GOLLETTE FAMILY DIVISION SUBDIVISION

APPLICATION NUMBER 14 DATE September 5, 2013

APPLICANT Gollette Family Division

REQUEST Subdivision

DETAIL SITE PLAN

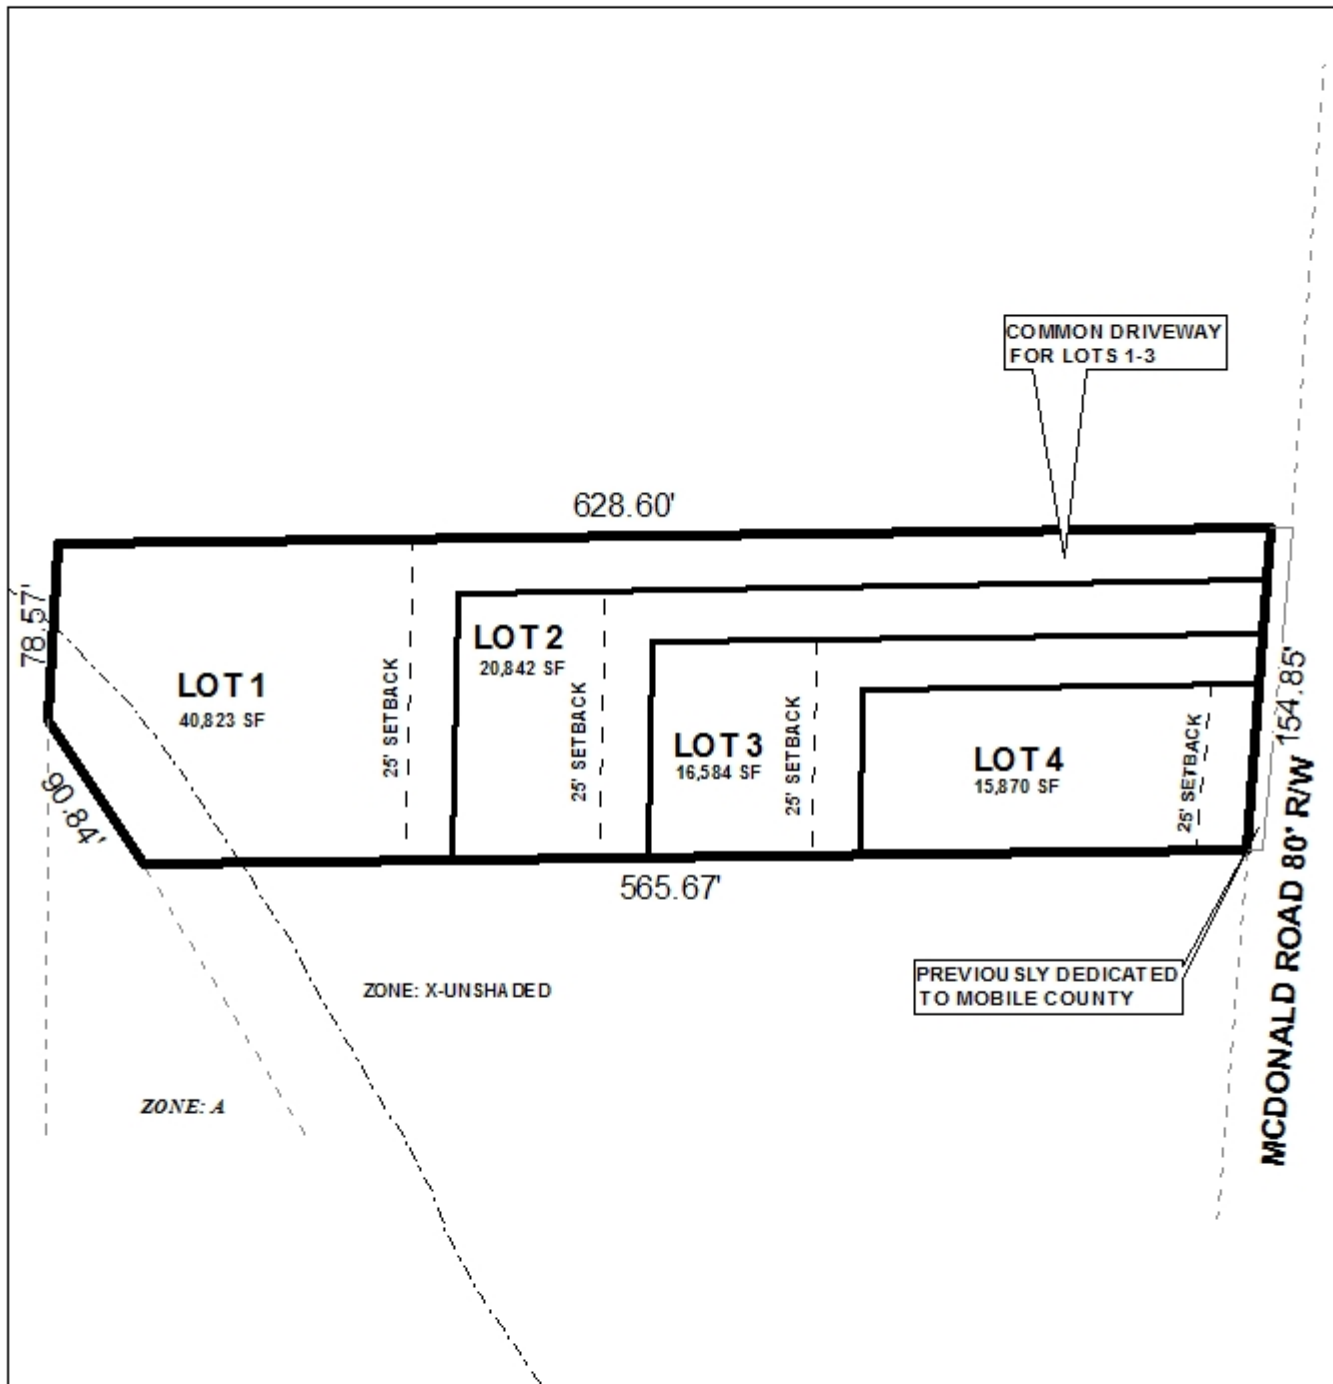
The intent of this application is to create 4 legal lots of record from one existing legal lot which was approved by the Planning Commission in 1997 as Lot 1 of Murdock Tanner Subdivision. It should be noted that the site has an overall depth of 628' ± but only provides 154' ± of street frontage along a public road. As a result, the proposed subdivision will create 3 flag lots due to a lack of road frontage. The applicant has not provided justification for the creation of a flag lot to substantiate their request and should refer to Section V.D.1. of the Subdivision Regulations regarding flag lots.

Due to the limited frontage, if approved, future subdivision of Lots 1, 2, or 3 should be prohibited until additional frontage on a public or private street is provided. This note should appear on the Final Plat if approved.

Section V.D.2. of the Subdivision Regulations mandates a minimum lot size of 15,000' for lots served by public water but not by public sanitary sewer. Staff questions if the "flag" portion of the lots will be of sufficient size to comply with Section V.D.2., if the "pole" portion is excluded from the lot size calculations. This concern is based upon the fact that a flag-shaped lot may not provide sufficient area to meet in-ground septic system field area requirements.

The 25-foot minimum building setback line is also depicted on the preliminary plat but should be revised for Lots 1, 2, and 3 and depicted as a box where the "flag" meets the "pole" of the lot and retained elsewhere on the Final Plat if approved.

The proposed subdivision has frontage along McDonald Road, an anticipated major street with an existing right-of-way width of 80 feet, but is required to have a right-of-way width of 100 feet as illustrated in the Major Street Plan. As a result, the current right of way is not sufficient and dedication is needed to provide 50' as measured from centerline.

The site has one existing curb-cut, however, as a means of access management, if approved, a note should be placed on the Final Plat stating that Lot 4 be limited to one curb-cut and Lots 1, 2, and 3 to share the existing curb-cut. The additional curb-cut along with any changes to the existing curb-cut are to be approved by Mobile County Engineering and conform to AASHTO standards.

- 1) The applicant has not provided justification for the creation of flag lots, per Section V.D.2. of the Subdivision Regulations;
- 2) Lots 2 and 3 will not have adequate area for septic systems exclusive of the "pole" portion of the lot.
